Notice of Proposed Amendment 2017-04

Regular update of aerodrome rules

CS-ADR-DSN — Issue 4

RMT.0591

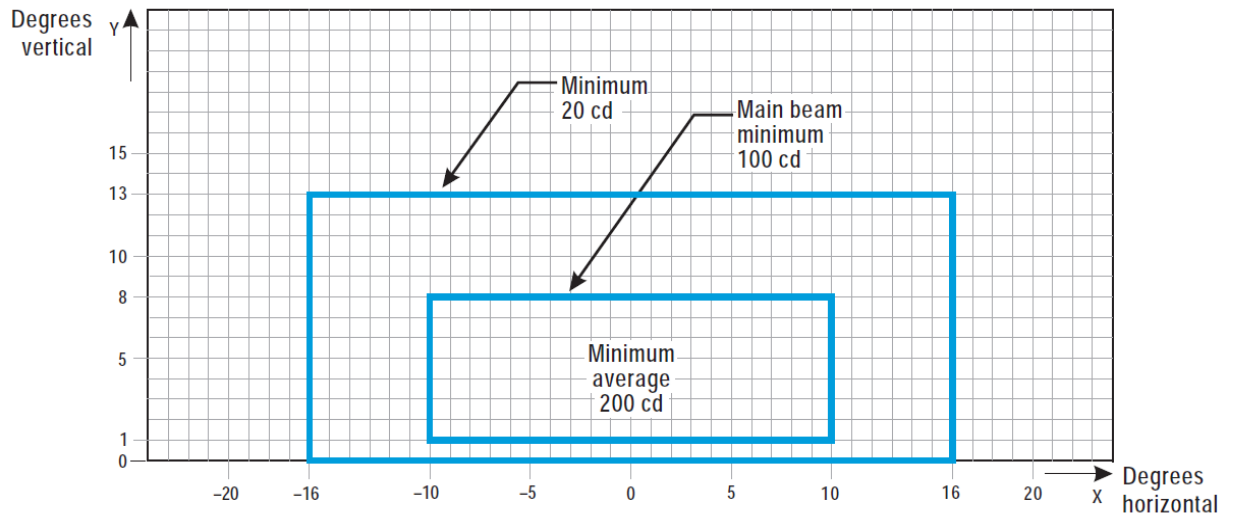
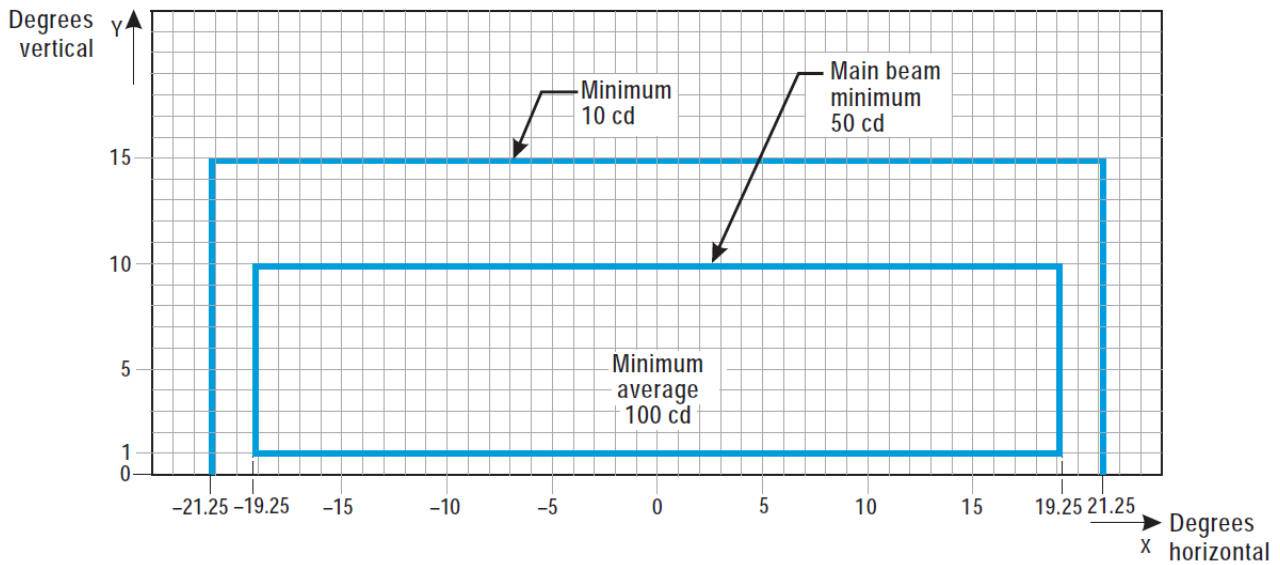
Figures U-16 and U-18 have been updated by adding in the titles 'RELS' (runway entrance lights); the notes under Figure U-18 have also been amended by adding the reference to the RELs.

Figure U-26. Light intensity distribution of PAPI and APAPI

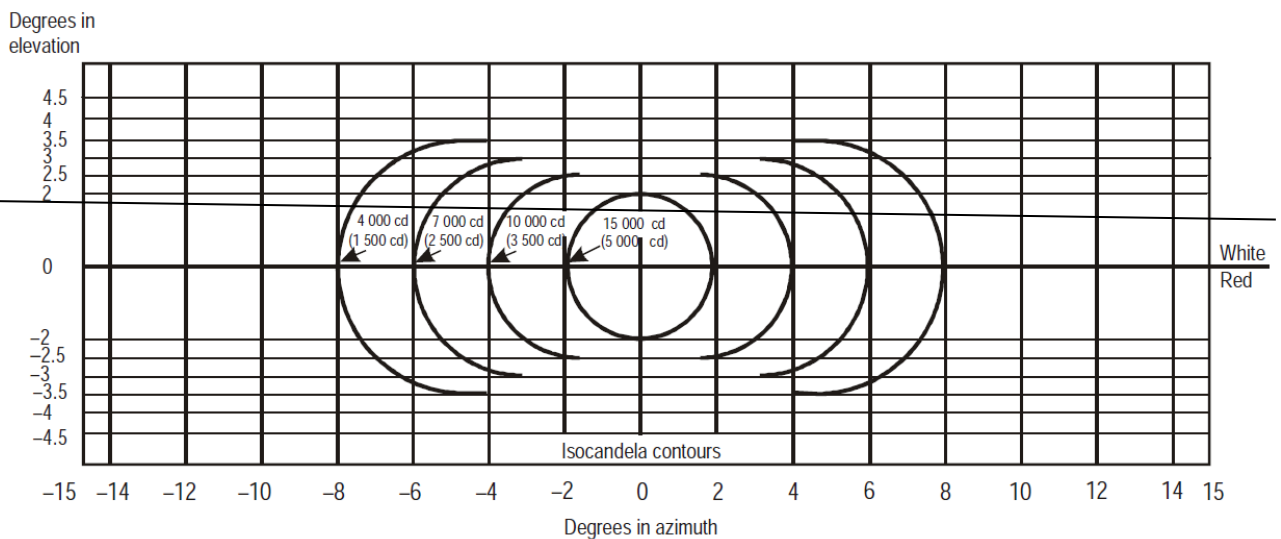
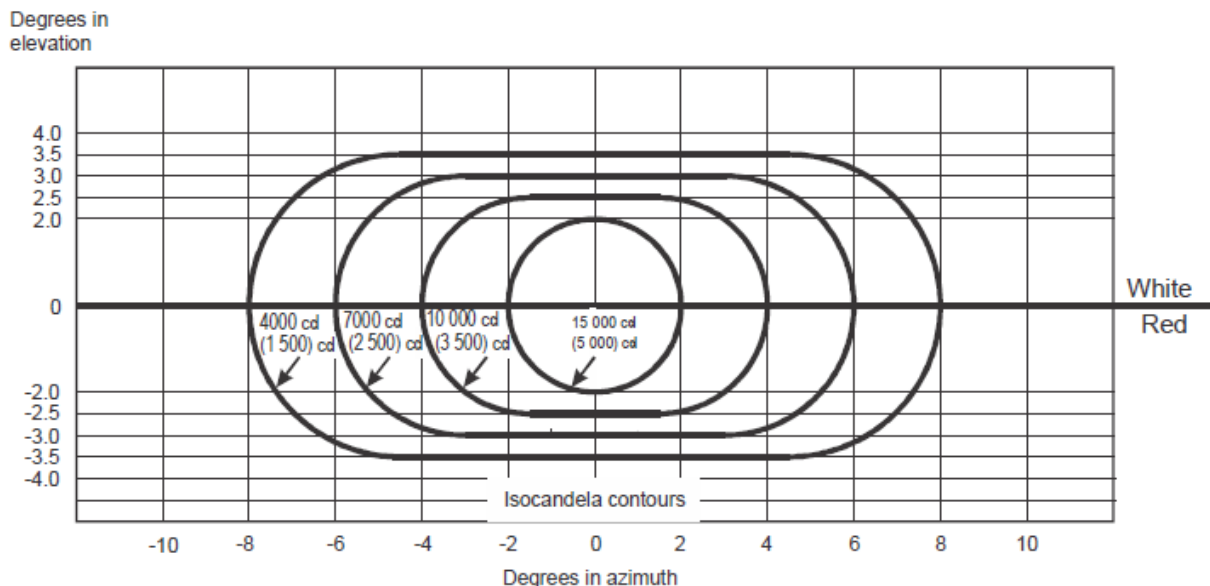
Figure U-26 has been replaced with the new one.

[Editorial note: Figure U-26 is deleted:]

[Editorial note: new Figure U-26 is added as follows:]

Figure U-29. Isocandela diagram for take-off and hold lights (THL) (red light)

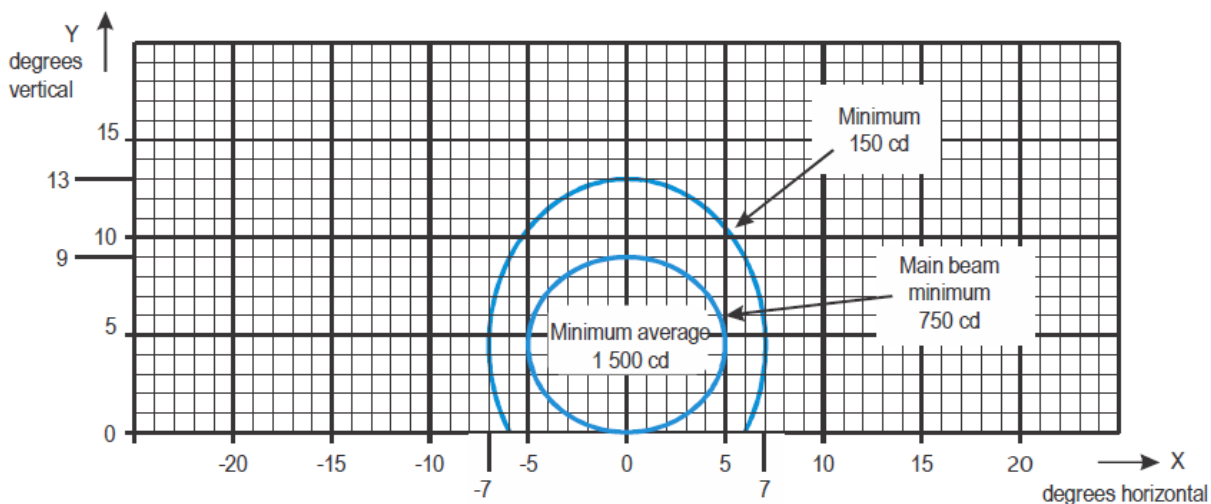
Figure U-29 has been added to provide an isocandela diagram for take-off and hold lights (THLs).

[Editorial note: new Figure U-29 is added as follows:]

Figure GM-B-3. Typical turn pad layout

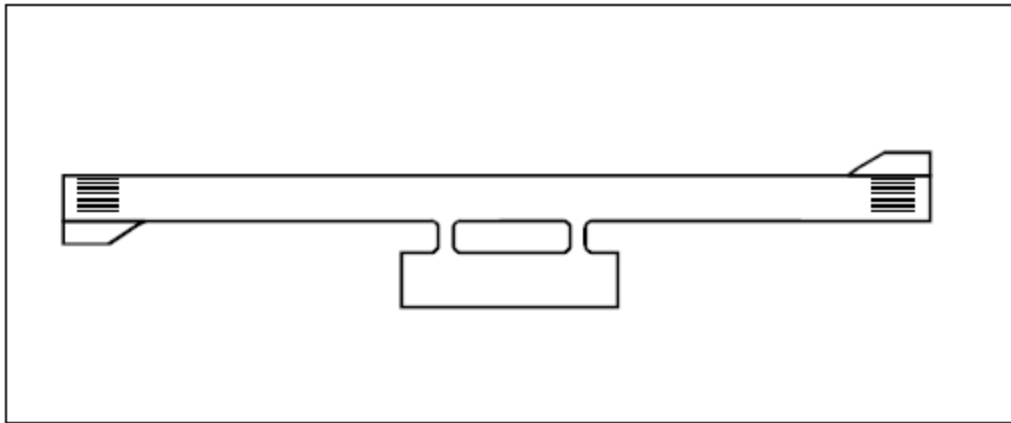
The reference to the wheel-to-edge clearance of 6 m for code E and F aeroplanes has been deleted. References to the typical turn pad layout figure are provided in GM1 ADR-DSN.B.095(a) and to the ICAO Aerodrome Design Manual, Part 1, 'Runways' in GM1 ADR-DSN.B.095(b).

- (a) ~~A typical runway turn pad layout is presented in Figure GM-B3 below:~~

Figure GM-L-2. Illustration of pavement marking spacing calculation

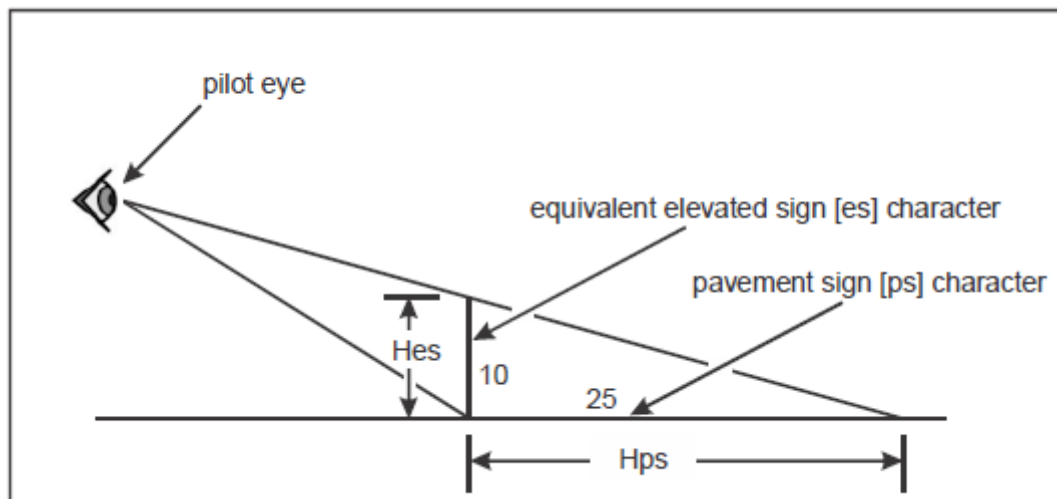
The GM has been amended in accordance with ICAO Annex 14, 'Aerodromes', Volume I, Amendment 13-A, by adding GM1 ADR-DSN.L.605(b), as well as Figure GM-L1. concerning the formation of the marking in the case of shadowing. GM1 ADR DSN.L.605(c) has also been amended containing examples of the calculation of the pavement marking spacing.
